Addendum #12 TP #5

PROJECT NAME: New École Évangéline– TP5

PROJECT #: 23059

ISSUED DATE: 2026-01-20

7 CAR CHARGER CONCRETE PAD SECTION
E-003 N.T.S.

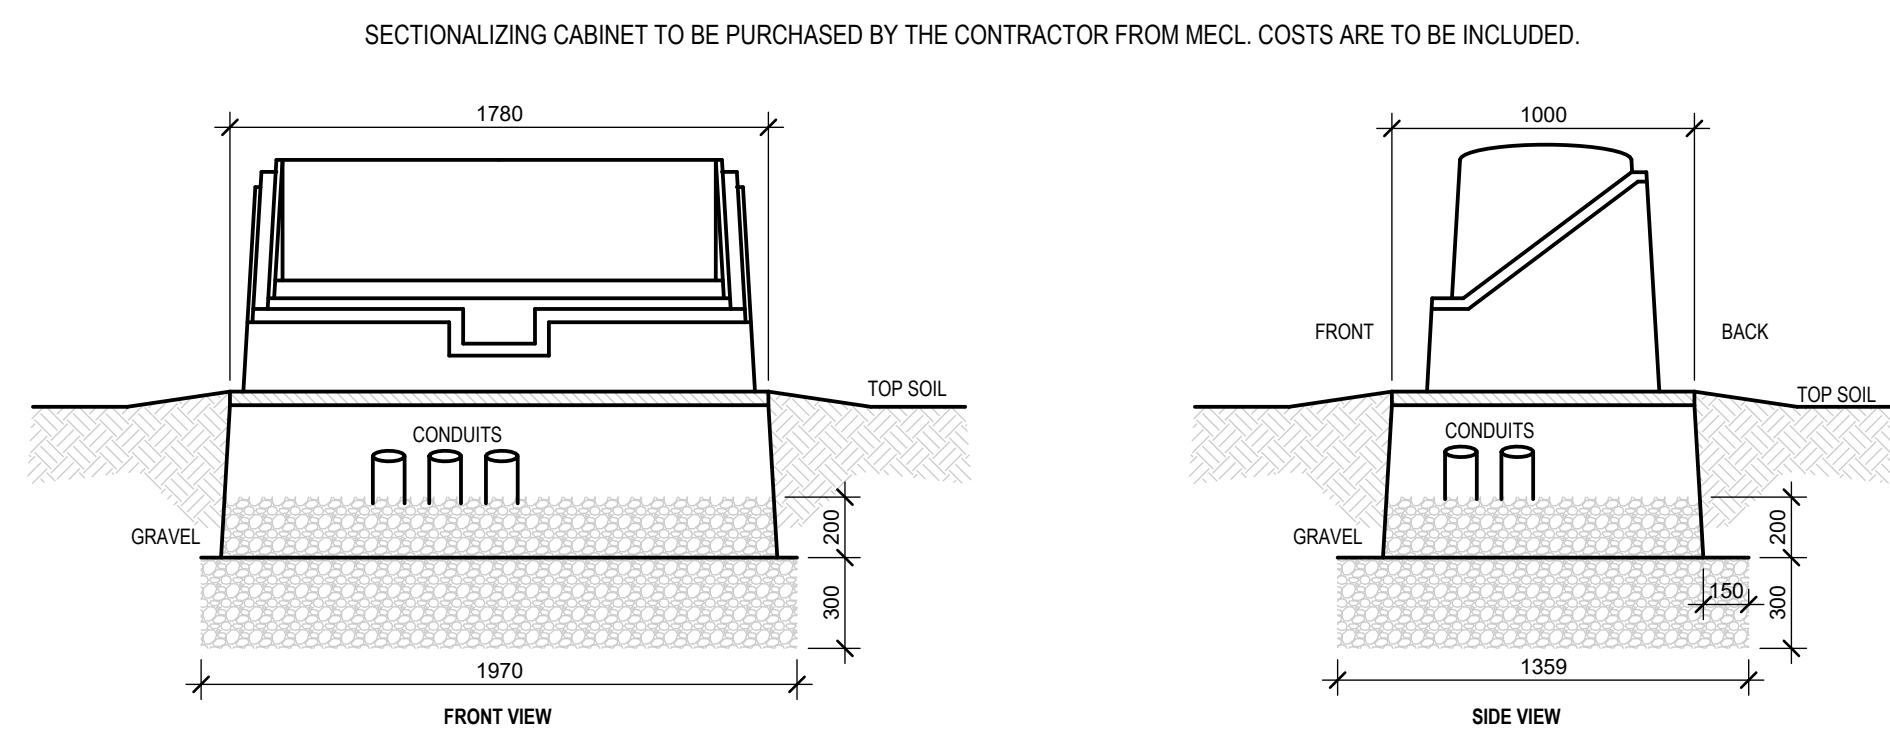
A12.2 Reference Addendum #11, dated 2026.01.20, Paragraph A11.9:

- .1 Delete “7/E-004” and replace with “7/E-003”.
